<b>Release Date</b>	05/05/2023	<b>Technical Service Bulletin</b>		
<b>93R5 UPDATE</b>				 <b>Audi</b>
<b>Retrofitting Connector Housing Cap – (NVLW)</b>

<b>This Update has been proactively released to prevent the following condition(s) from occurring in the vehicle:</b>	
Criteria	Technical Background
01	On Audi e-tron GT / RS e-tron GT vehicles manufactured within a specific period, water may enter the high-voltage connector housing due to a production irregularity.

Criteria	Remedy
01	Install a connector housing cap.

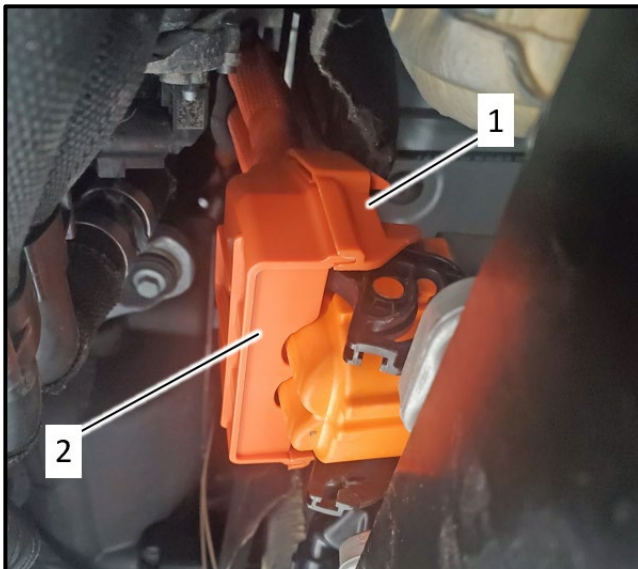
- Install connector housing cap around HV battery connector housing.

- Install rear cap <1> first.
  - Part number = 4J3-971-921.
- Then install front cap <2>.
  - Part number = 4J3-971-920.
- Ensure the two halves are clipped together.
